ICOMOS

Report on the ICOMOS Advisory Mission to Masjed-e Jāmé of Isfahan (C 1397)

29th June to 3rd July 2014

Fig 9. Meydan-e Atiq revitalization project: Revised plan of the north square section (source Nagsh-e Jahan – Pars Consultant)

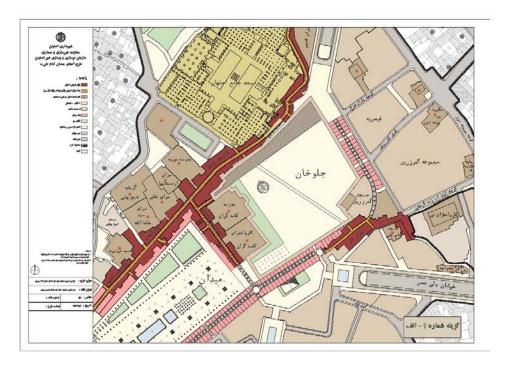
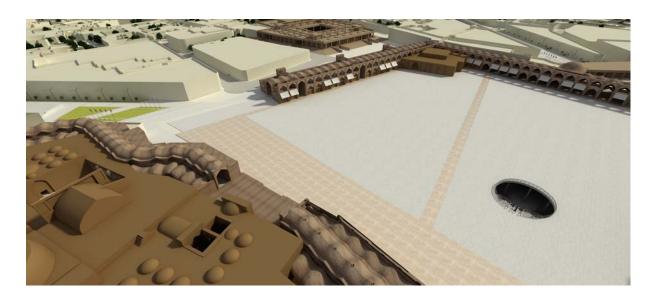
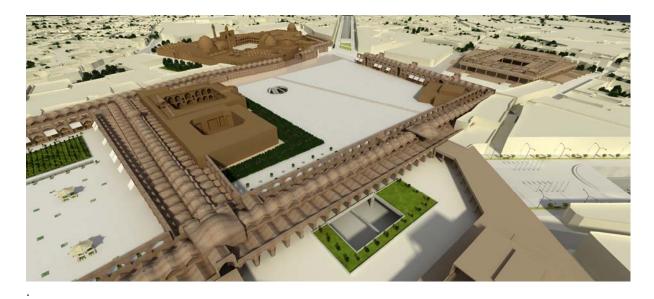
- the revised plans of the project concerning the area in front of the south-east elevation of Masjed-e Jāmé, show that the new galleries will have no structural connection with the eastern wall of the Mosque nor with the structures of the existing covered bazaar flanking the Mosque;
- while the plans of the revised design of the project, transmitted to the ICOMOS expert during the mission, foresee the demolition of some structures of the existing bazaars located in front the Masjed-e Jāmé south-east entrance, the State of Conservation report transmitted in 2013 by the State party quotes (on page 14) "In addition to that, the recent revision recommends keeping and preserve the presently existing buildings on the north-western side of the square which is connected to the mosque. This side needs to meet minimal intervention but partial maintenance and restorations"

The mission has requested the ICCHTO authorities to provide updated information and/or plans on this issue. ICCHTO authorities have expressed their engagement to answer as soon as possible.

Following the request for clarifying information on the final design concerning the "presently existing buildings on the north-western side of the square which is connected to the mosque," the mission recommends the ICCHTO authorities to provide updated information and plans on this issue at the earliest convenience.

Fig 13. Plan of *Meydan-e Atiq* after modification Previous plan ----- revised plan ----- (source: 2013 SOC report)

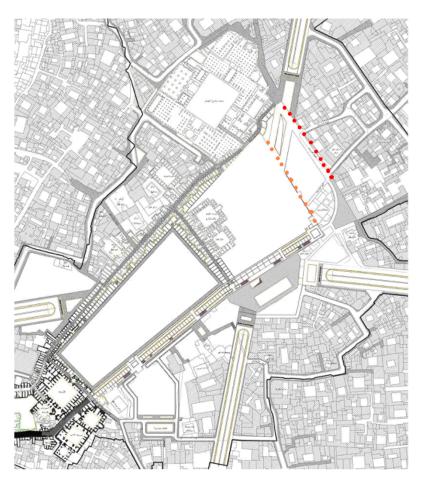
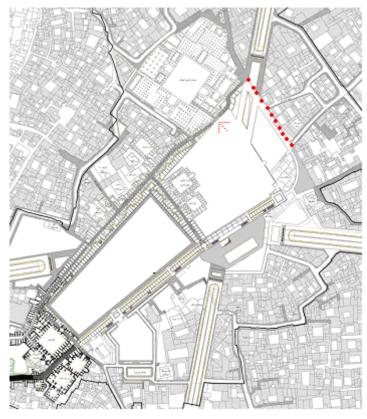
Considering the new functional organization of the Meydan-e Atiq project, it is likely that the important visitor flows coming from the south section of the square with its new bazaar galleries, and from the underground parking facilities, will enter the north section of the square and have access to the south-east Mosque gate.

Large crowds always constitute a risk in a traditional historic centre, and this issue should be tackled, as requested by the Committee, through a proper management plan that foresees public accessibility regulations, especially considering the huge capacity of the Meydan-e Atiq, and its underground facilities, such as bus/car parking and gathering hall, to host large quantities of people.

The CAD plans and renderings of the revised design show a huge empty space in front of the Masjed-e Jāmé south-east gate, but as they are at urban scale, they do not specify how the pedestrian flows will be organized within this area.

The mission recommends the State party to integrate into the revised design of the north square section, which according to the latest information received after the mission is still in progress, plans of an appropriate architectural scale, detailing the pedestrian circulation organization within the area.
